WATERVUE

643-651 HUNTER STREET NEWCASTLE NSW 2300

DEVELOPMENT APPLICATION SHEET LIST		
DRAWING NO.	TITLE	REVISION
DA000	PLAN - LOCATION & DRAWING SCHEDULE	F
DA002	SITE ANALYSIS	B
DA003	PREDICT LOCATION PLAN	C
DA005	SITE PLAN	B
DA006	SHADOW DIAGRAMS	B
DA007	SHADOW DIAGRAMS	B
DA008	SHADOW DIAGRAMS	A
DA009	SOLAR ACCESS DIAGRAM	B
DA010	VENTILATION DIAGRAMS	B
DA011	PLANNING - GFA	C
DA012	UNIT AREA FOR CARPARKING GEN.	B
DA101	GROUND FLOOR	E
DA102	PARKING LEVEL 1	D
DA103	PARKING LEVEL 2	C
DA104	PARKING LEVEL 3	C
DA105	PLAN - PODIUM	E
DA106	PLAN - TYPICAL LOWER	D
DA107	PLAN - TYPICAL UPPER	C
DA111	PLAN - PENTHOUSES	B
DA112	ROOF	B
DA200	STREETSCAPE ELEVATIONS	B
DA201	ELEVATIONS - NORTH AND EAST	F
DA202	ELEVATIONS - SOUTH AND WEST	C
DA301	SECTIONS	C
DA321	RAMP SECTION CARPARK	C
DA401	PERSPECTIVE	B
DA402	PERSPECTIVE	B
DA403	PERSPECTIVE	B
DA409	MATERIALS + FINISHES	B
DA801	PODIUM LEVEL PRIVACY SCREENS	A
DA802	SIGNAGE DESIGN INTENT	A

DRAWING No.	DA000
DRAWING TITLE	PLAN - LOCATION & DRAWING SCHEDULE
SCALE	1 : 1 @ A1
DATE	2023

DRAWING No. **DA002**
DRAWING TITLE **SITE ANALYSIS**
SCALE
DATE **2022**

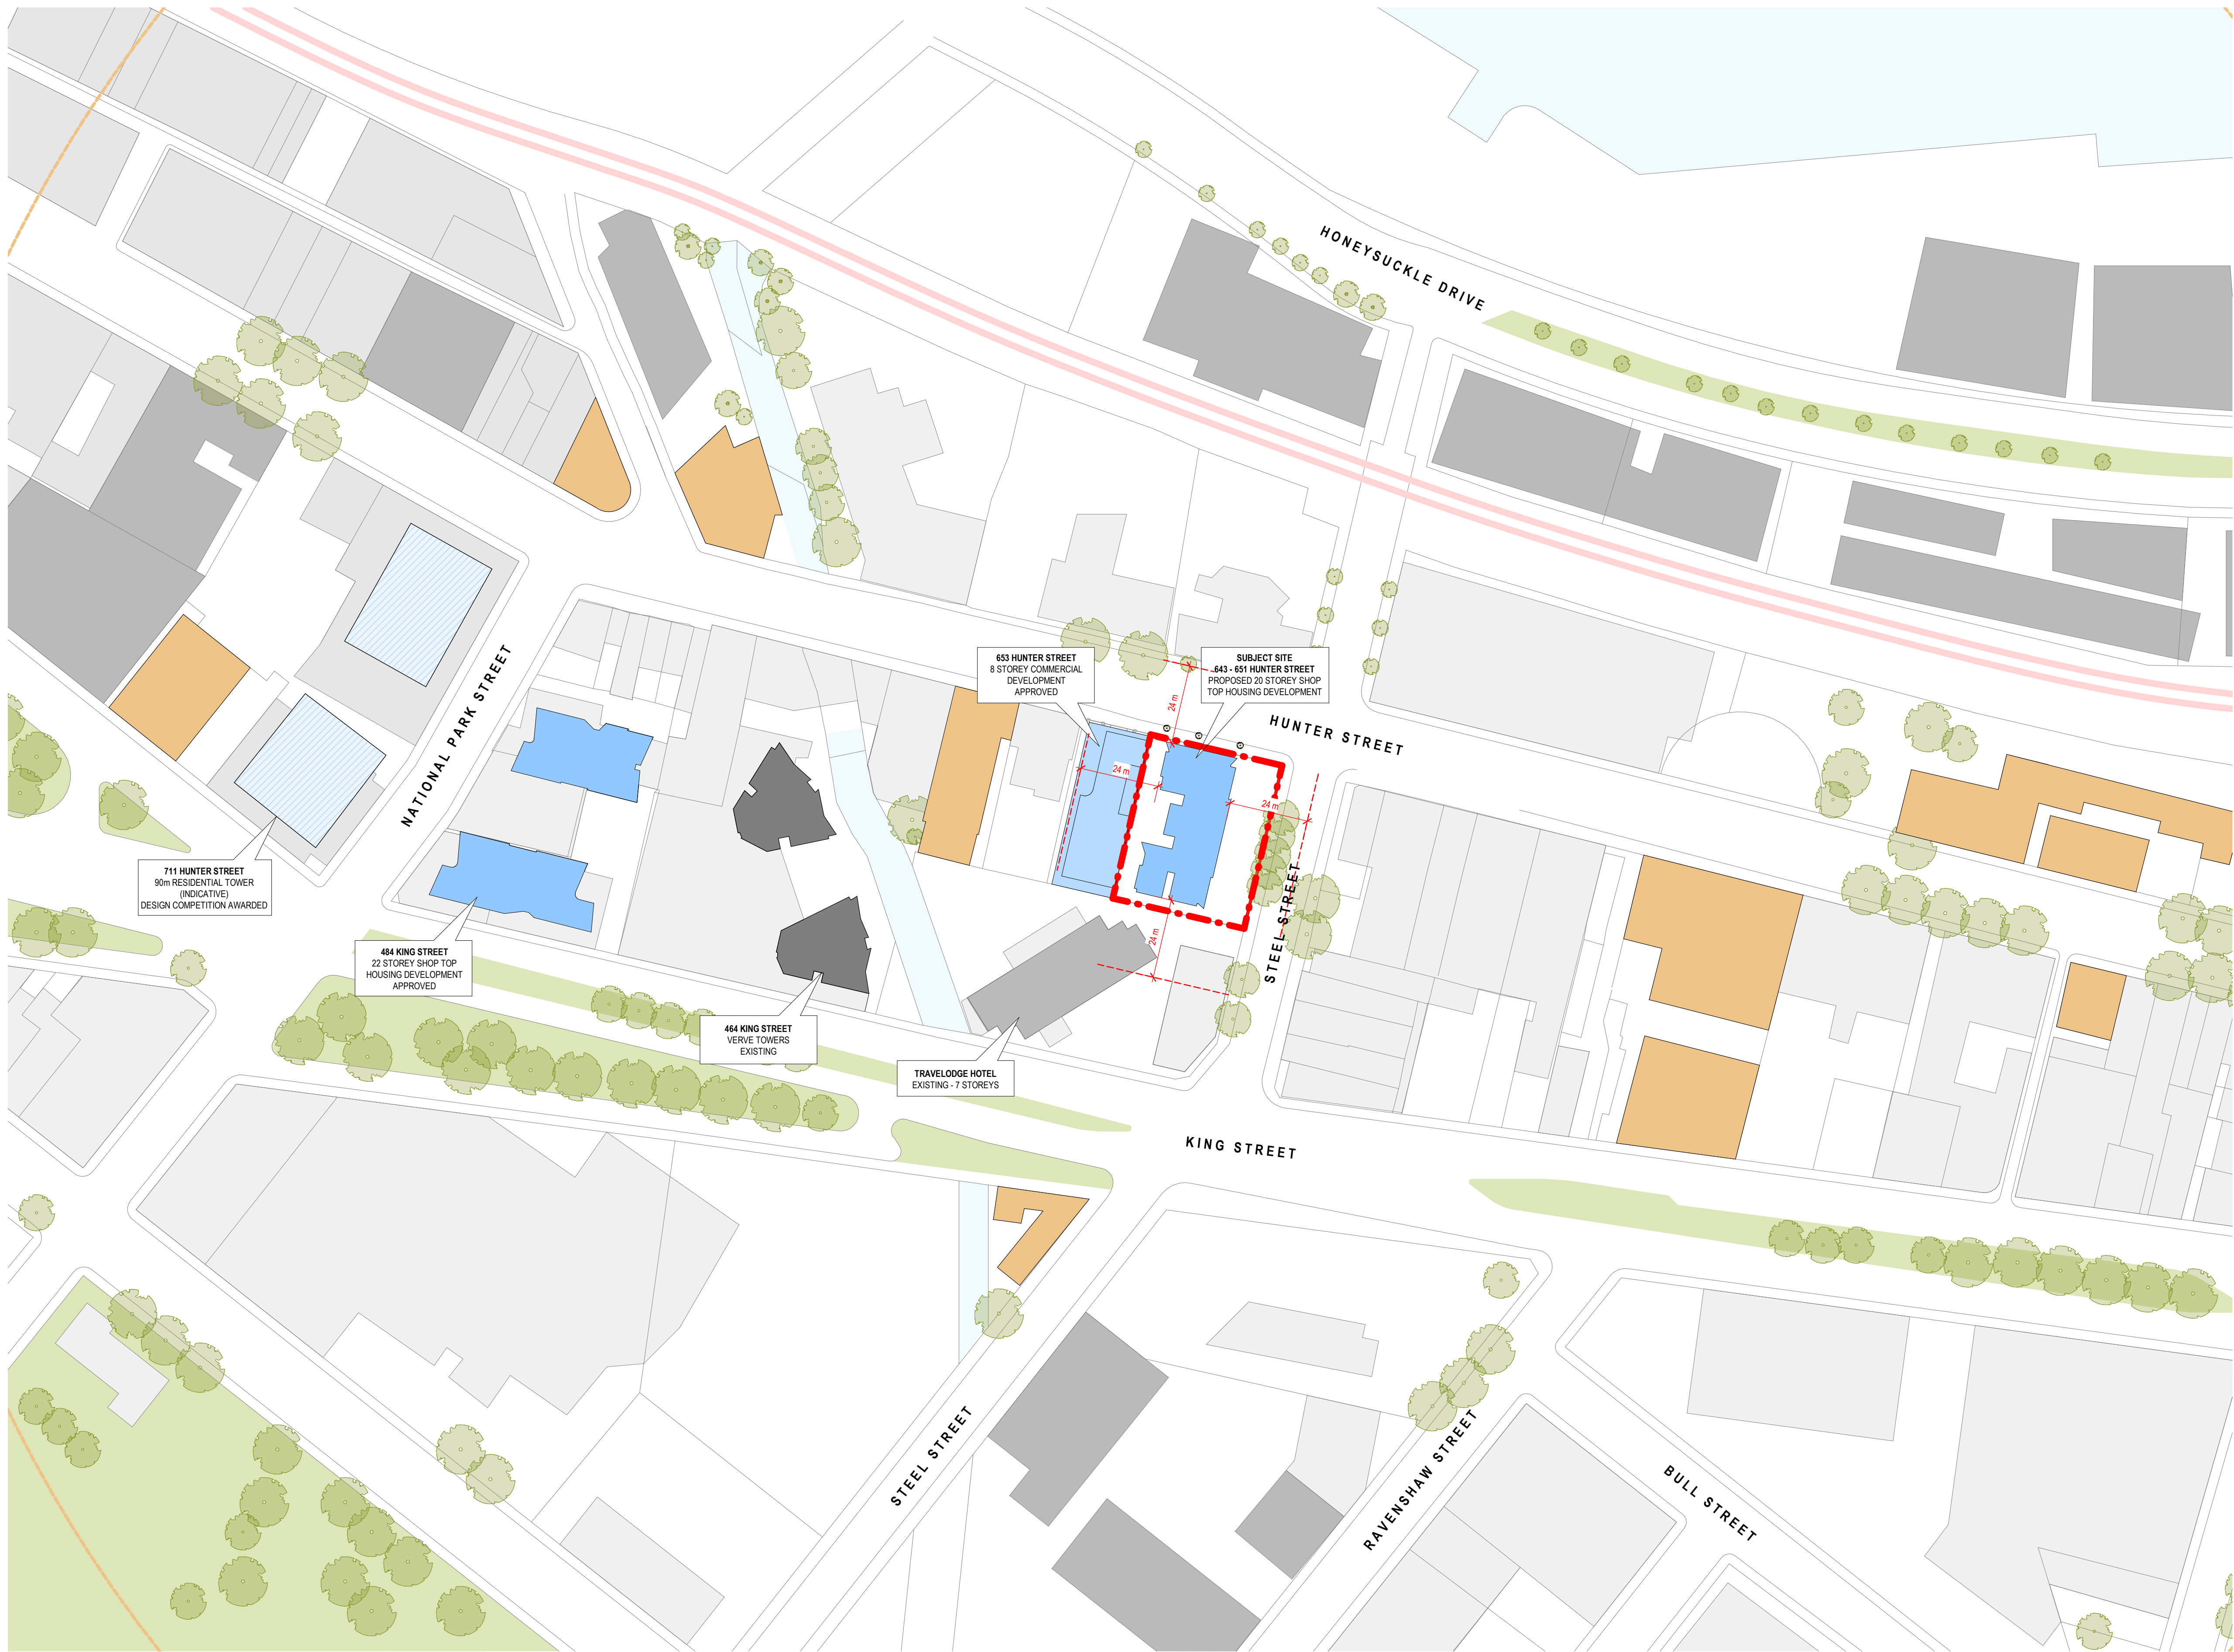
DA RfIs - 27.03.2023
24m BUILDING SEPARATION LINE ABOVE 45m INDICATED
PRIVACY SCREEN LOCATION CLARIFIED

DRAWING No. **DA103**
DRAWING TITLE **PARKING LEVEL 2**
SCALE **1:100 @ A1**
DATE **2023**

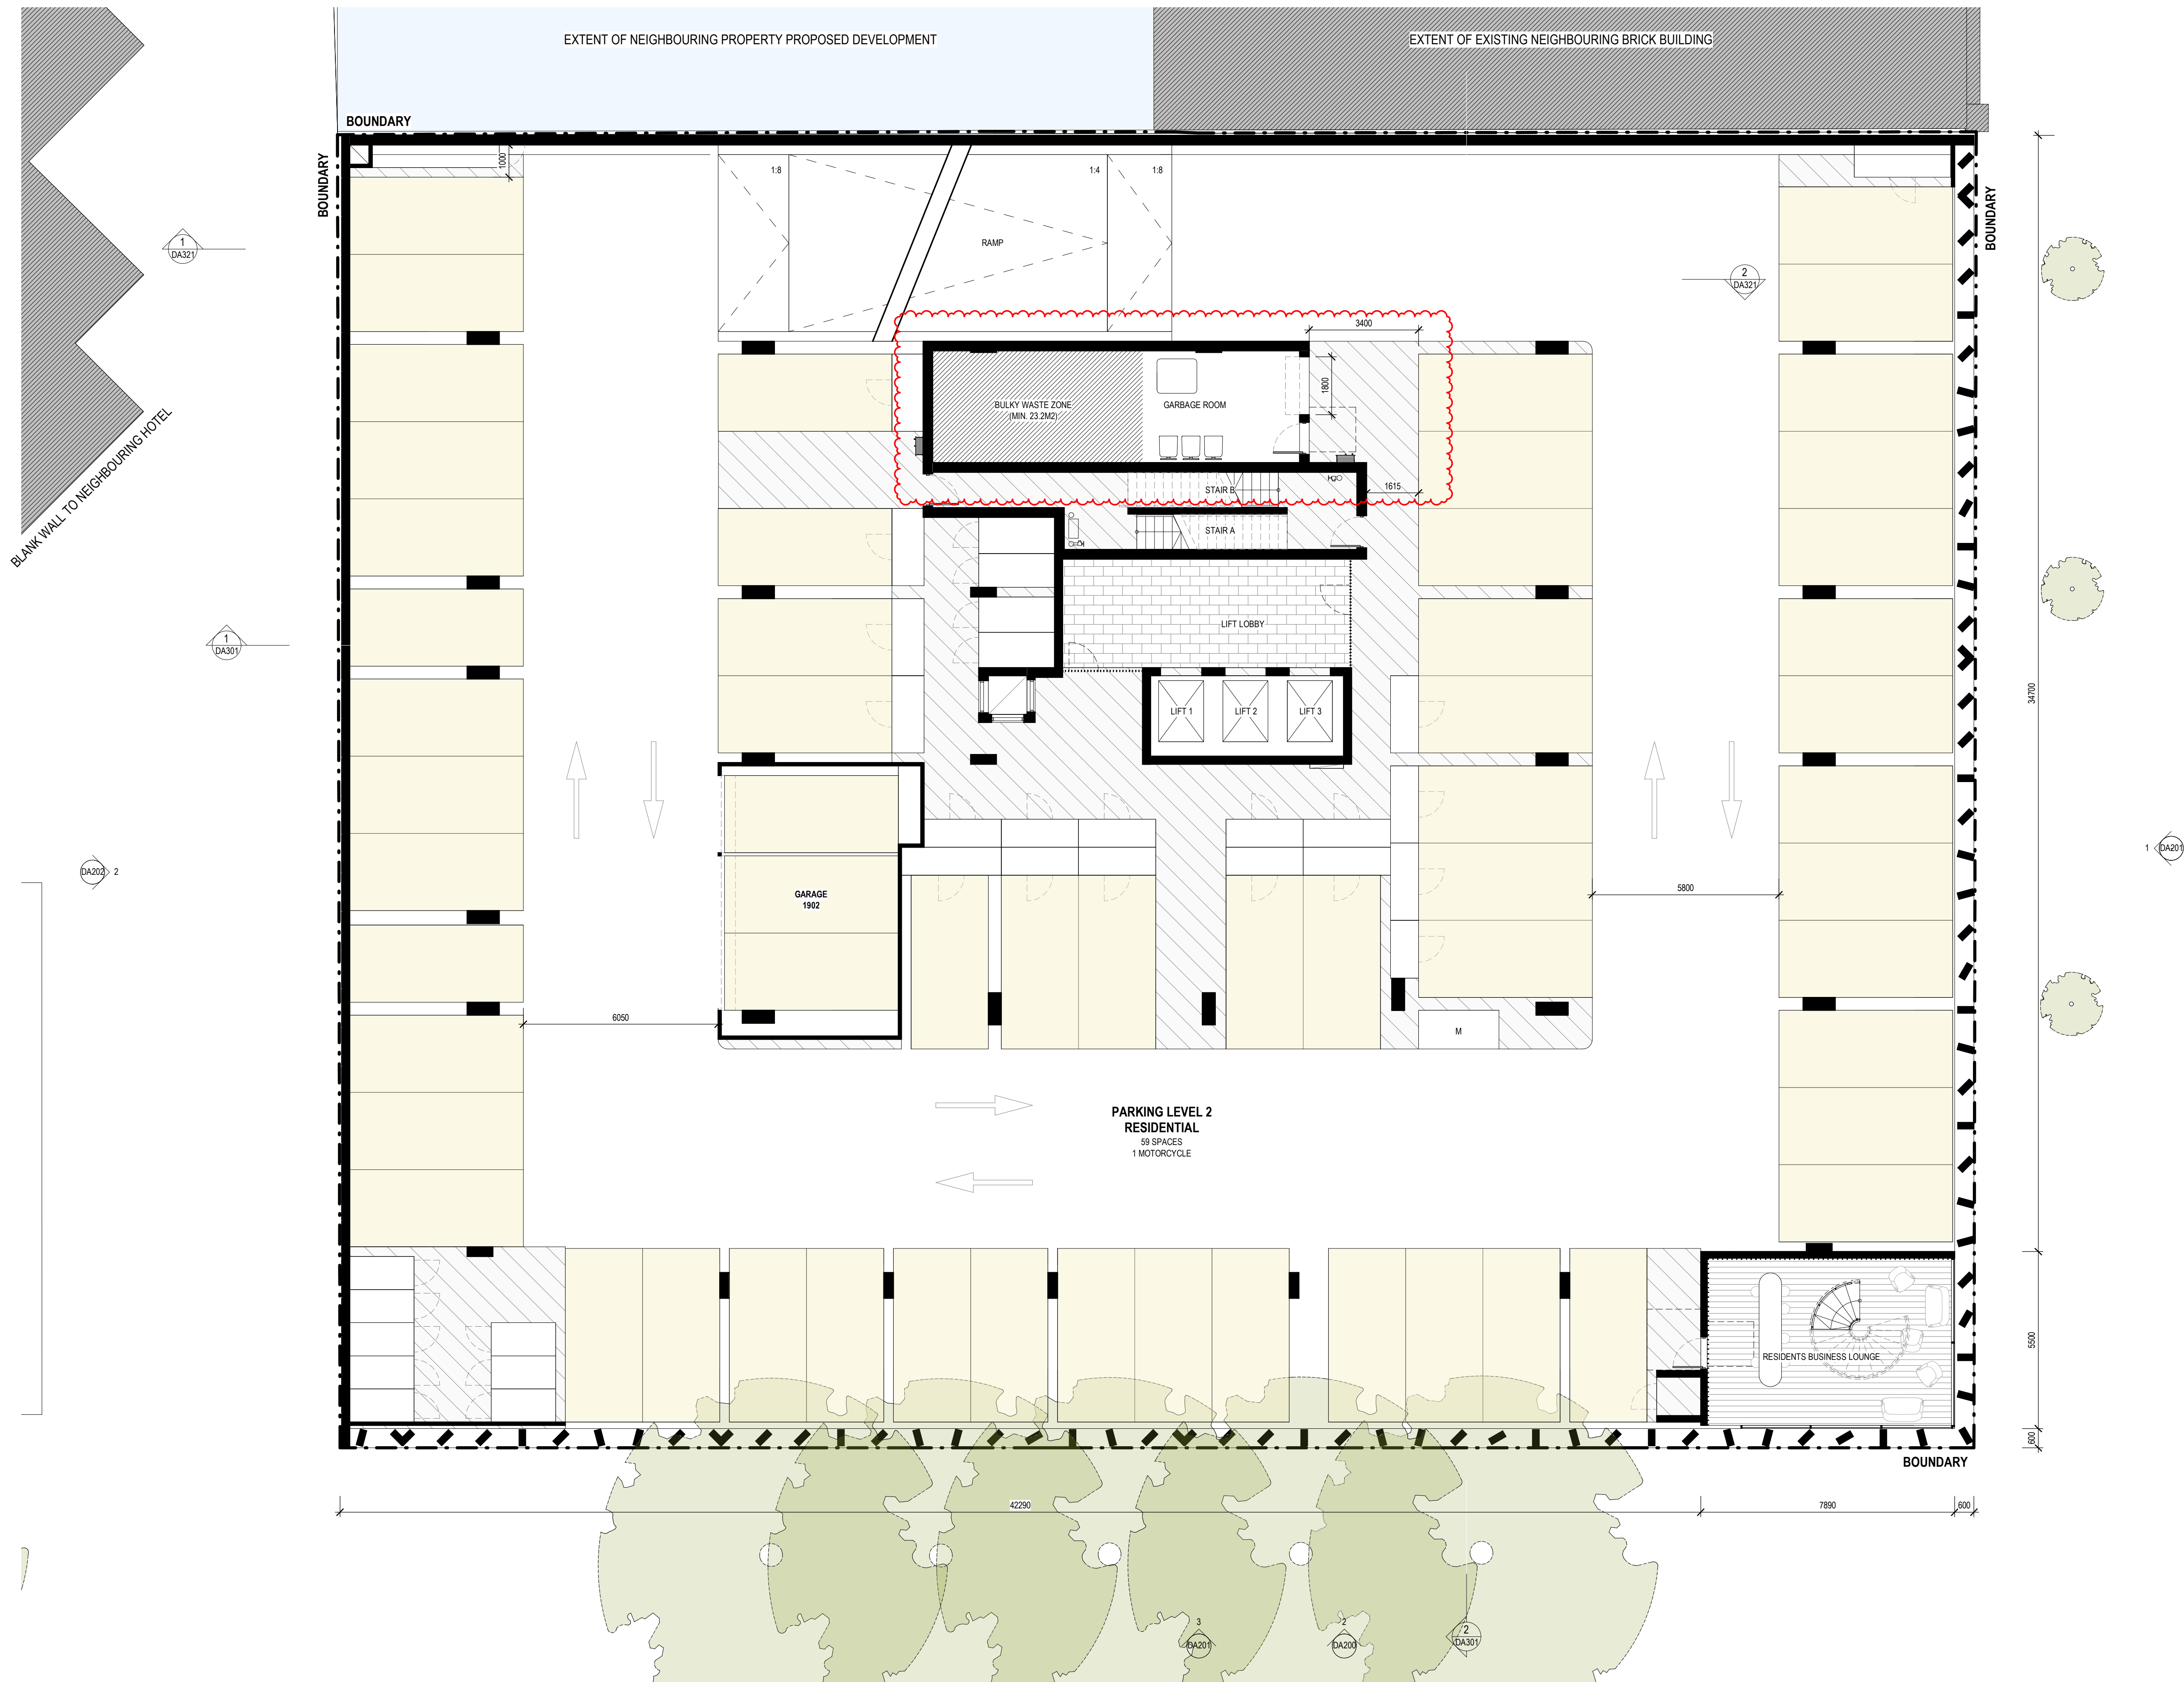
DA RFIS - 17.02.2023

- NOTCHES IN AWNING ADDED
- FUTURE STREET TREE CLEARANCE INDICATED
- ADDITIONAL RAMP SECTION PROVIDED
- RAMP EDGE CONDITION CLARIFIED
- COMMERCIAL TENANCY STORAGE, WICS, COMMS ROOM, MAIL ROOM RECONFIGURED TO CREATE FLOOD EVACUATION PATH
- STAIRS REMOVED
- STAIRS REMOVED RAMP ADDED
